BAR Meeting
January 7, 2009

ISSUE: New Construction
APPLICANT: Sophie Development LLC
LOCATION: 714 Wythe Street
ZONE: OC/Office Commercial

Figure 5. Proposed front (north) elevation.

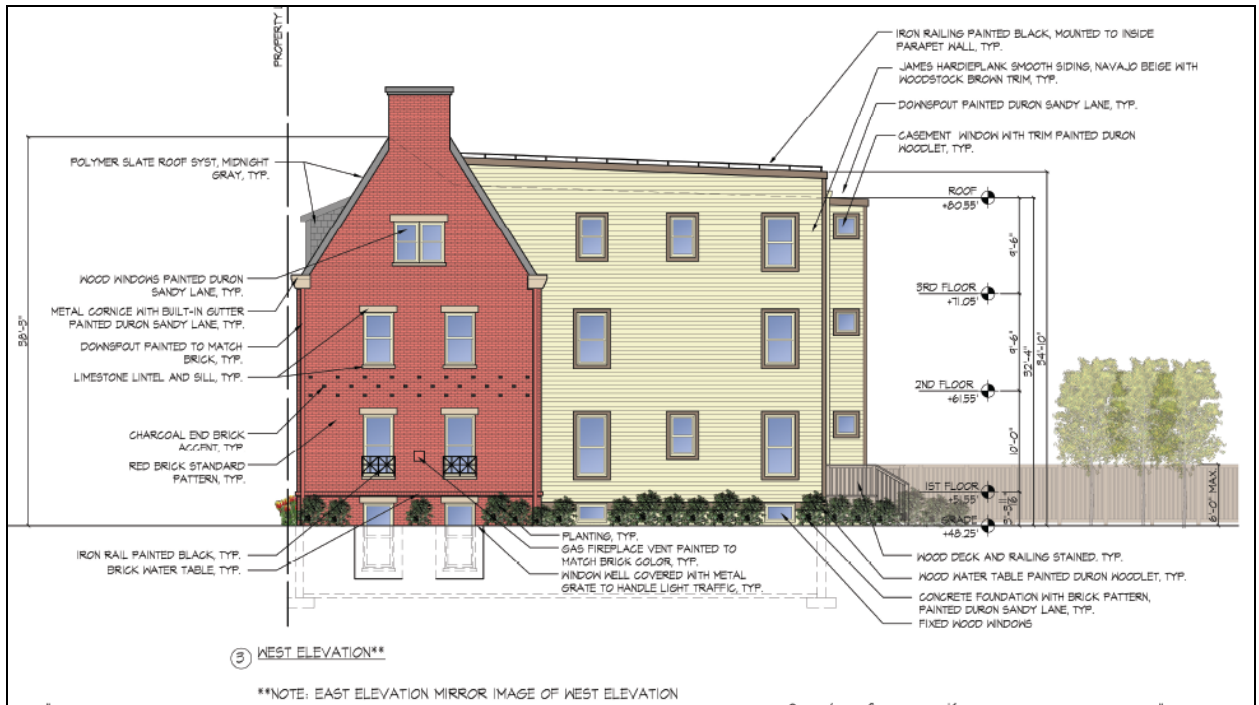
Staff finds that the style, massing, height and fenestration of the front elevation are generally appropriate. The three-story building reads as a two-story-plus-attic building and reflects the general architectural patterns found throughout the historic district. The first story windows are taller than the second story windows, reflecting traditional fenestration patterns. The *Design Guidelines* note the following about dormers: “dormer sashes should be operable and should be the same type as the other window sashes on the structure,” “shed dormers are strongly discouraged,” and “dormers should match the existing proportions of the building and the windows.” Staff has informed the applicant that shed dormers on prominent elevations are generally not approved by the Board. The applicant has studied various dormer configurations and styles and concluded that the shed is most appropriate for this design as it minimizes height and prominence on the third story. The applicant provided studies of various dormer types and configurations to BAR Staff and the City Architect. While the *Guidelines* discourage shed dormers, it is important to note that the *Guidelines* encourage reviewing each design on a

case-by-case basis and to acknowledge that the *Guidelines* are general directions rather than strict prescriptives. Staff also notes that there are some examples of front elevation dormers on historic buildings within the district. As a result, Staff finds that the proposed shed dormers, smaller and more refined than those originally proposed, are the most supportable design solution for this project.

In the earlier analysis, Staff noted that a more historically appropriate approach to this type of building (two townhouses as one building), was to slightly delineate the two dwellings through the application of a small amount of ornament or detailing. Staff does not object to the central entrance and finds that the differentiation of the two townhouses provides a more accurate reading of the building from the street. Staff finds that the use of a recessed piece at the center of the limestone lintel, a vertical line of recessed brick at the second story, and a break in the cornice at the center property line successfully differentiates the building as two townhouses. Staff does not find that the use of a line of different color synthetic slate appropriately differentiates the buildings at the roof. Staff recommends that the applicant remove the different color slate at the roof. While a projecting decorative metal coping at the center dividing line on the roof would be most appropriate, Staff does not find it essential to differentiate the two townhouses at the roof.

S-1 The Fypon cornice shown on Sheet 6 looks oversimplified/undetailed for the architecture—it should have more detail without being too historicist. It would appear more in keeping with the rest of the design if it had some subtle historical detailing but was not overly ornate.

F-1 As we have discussed, the use of shed dormers on the front slope of the roof is unusual. Their argument in this case is that it helps minimize the visual bulk of the houses (particularly the roof.) While this is probably a valid argument, gabled dormers would be more typical. I prefer to leave this debate up to the Board.

Figure 6. Proposed side (east and west) elevations.

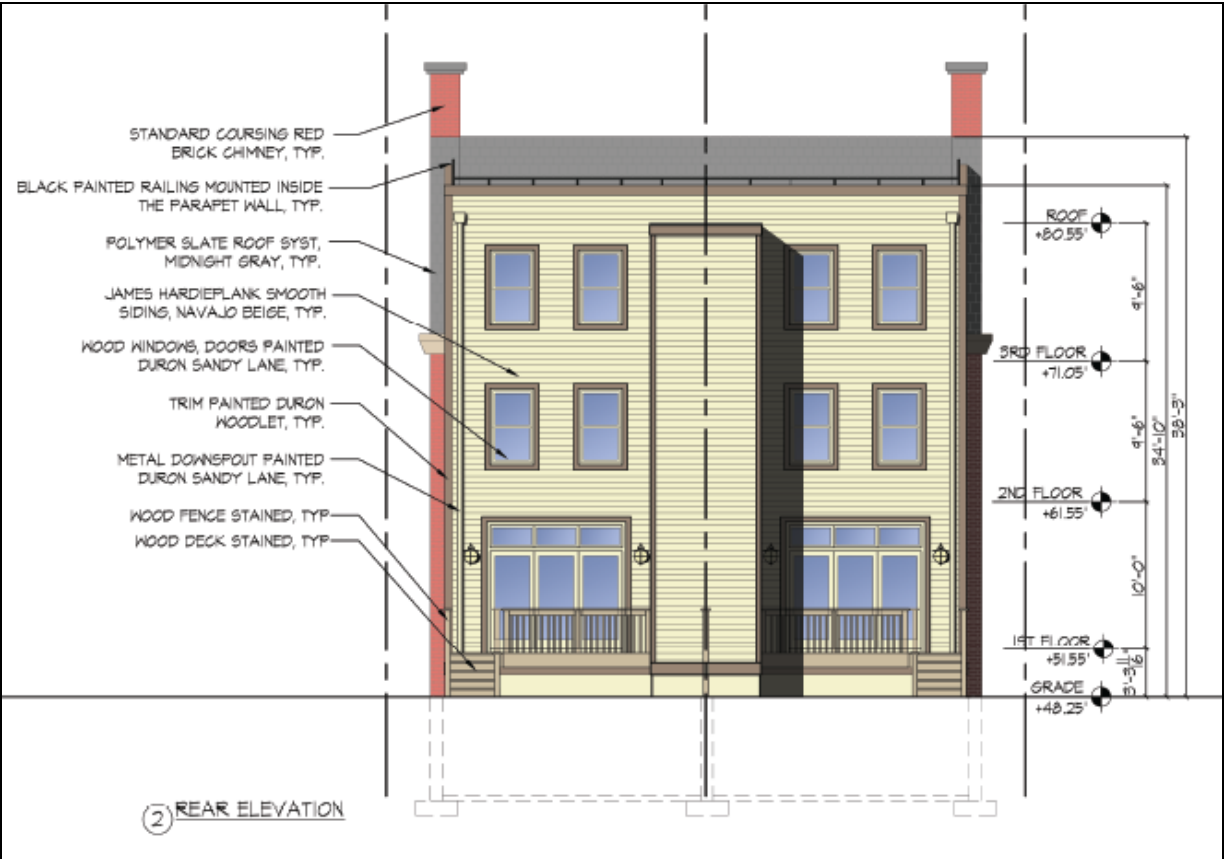
The side elevations are both bounded by public alleys, making the side elevations highly visible. Staff finds that the transition on the side elevations from the brick portion to the frame portion is appropriate. As houses evolve and change over time, the introduction of a new building material, such as siding on a rear frame addition to a main block of brick, often occurs. However, what generally makes such different materials and forms successful is that the rear portion is lower than the main block. The applicant has revised the design to extend the depth of the brick portion, thereby reducing some of the original bulk of the frame portion. In addition, the applicant has reduced the height of the rear portion and eliminated the penthouse roof access hatch that was projected several feet above the roofline of the frame section. Initially, Staff was concerned that the proposed fenestration on the frame portion was disjointed from the front elevation and generally inappropriate. The applicant has since revised the fenestration of the side elevation to be more historically appropriate through the use of single windows and a reduction in size of the third story windows. The *Design Guidelines* discourage awning windows. Although discouraged, Staff notes that they are acceptable in the minimally visible location of the small rear projection on this building.

Staff has no objection to the use of porous grass pavers running along the side elevations. Staff finds that the use of foundation plantings is more appropriate on the side elevations than the plastic bollards originally proposed.

Figure 7. Proposed rear (south) elevation.

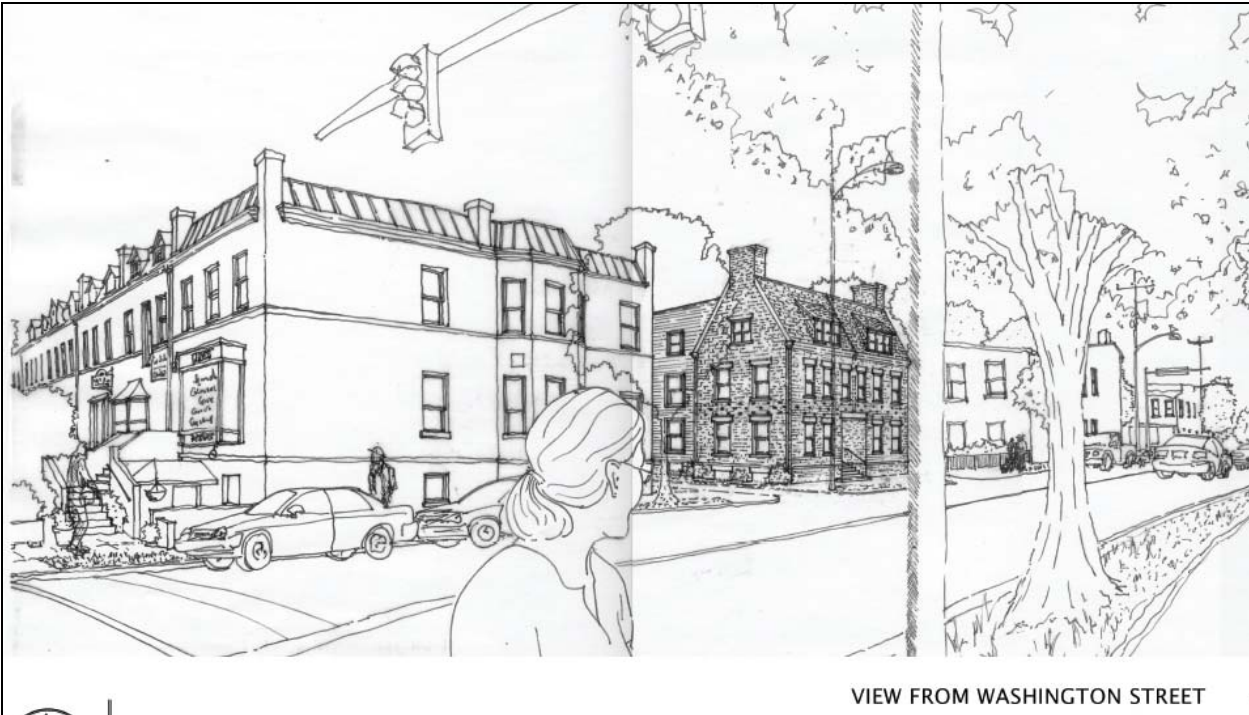
The rear elevation will be visible from the alleys and from Pendleton Street. The rear yard will also have a 6' high wood fence, making the first story less visible. The reduced ornamentation on this elevation and the simple fenestration and reinforces the hierarchy of elevations.
